Docket Number:	15-AFC-02
Project Title:	Mission Rock Energy Center
TN #:	213893
Document Title:	Mission Rock Energy Center, Data Request No. 115 with Guidance
Description:	Cultural Resources Data Request 115 along with Staff General Guidelines for Conducting Historical Resource Surveys
Filer:	Mike Monasmith
Organization:	California Energy Commission
Submitter Role:	Commission Staff
Submission Date:	10/4/2016 2:40:14 PM
Docketed Date:	10/4/2016

RE: MISSION ROCK ENERGY CENTER (15-AFC-02) DATA REQUEST No. 115

**MISSION ROCK ENERGY CENTER (15-AFC-02)
DATA REQUEST No. 115**

Technical Area: Cultural Resources

Reduced Architectural Survey Area
Mission Rock Energy Center
(15-AFC-02)

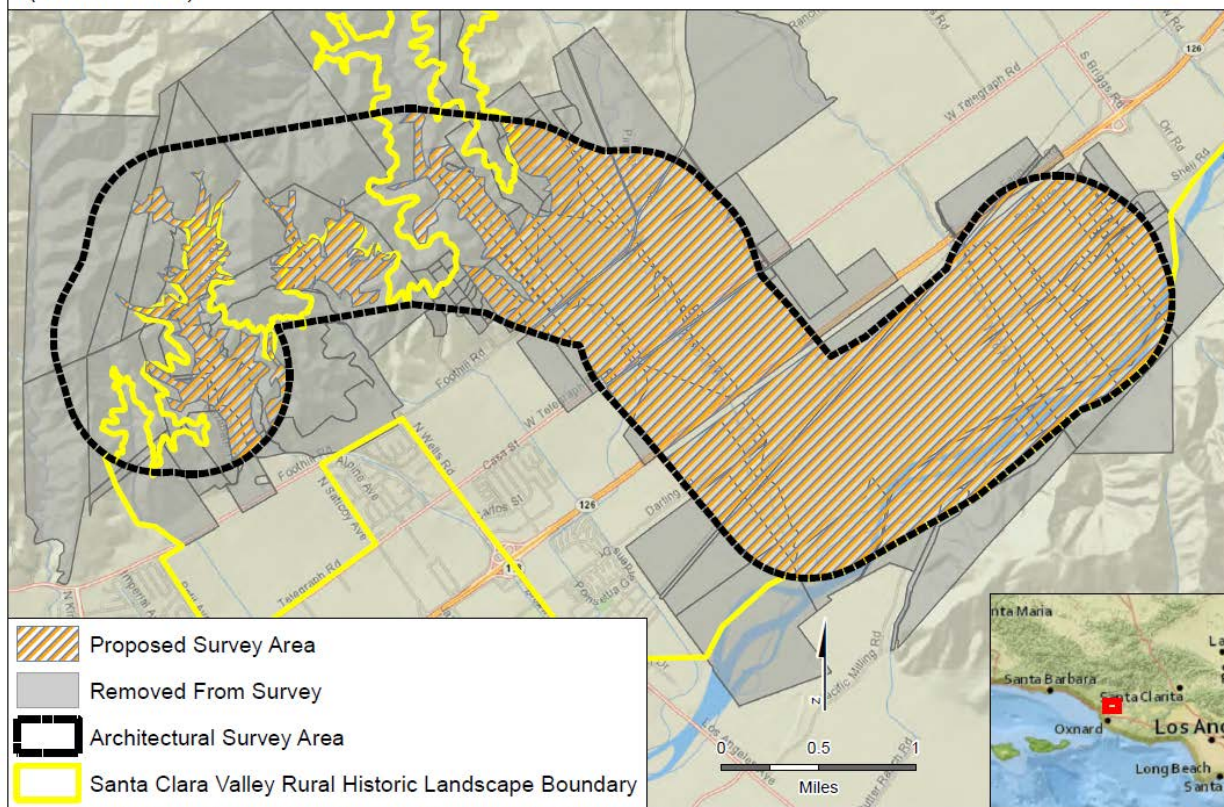
The applicant objected to completing the cultural resources windshield survey as described in Appendix B, largely on the basis that the survey area was too large and contained too many property owners for a cultural resources survey to be a reasonable undertaking. Staff has made a good faith effort to apply a set of criteria that reduces the survey area while still capturing the majority of cultural resources in the Project Area of Analysis (PAA).

- Remove parcels included in the survey area which only slightly overlap with the PAA;
- Remove portions of parcels outside the PAA;
- Reduce the survey area by eliminating land with a slope unlikely to contain cultural resources that contribute to the historic landscape;
- Reduce the survey area by eliminating parcels with development not consistent (less than 45 years of age) with the built environment resources that contribute to the historic landscape.

However, if cultural resources are identified outside of the reduced survey area, staff reserves the right to analyze impacts to these resources at a later date and as part of its independent analysis of important contributors to the historic landscape. The following map represents the remaining survey area after applying the above criteria.
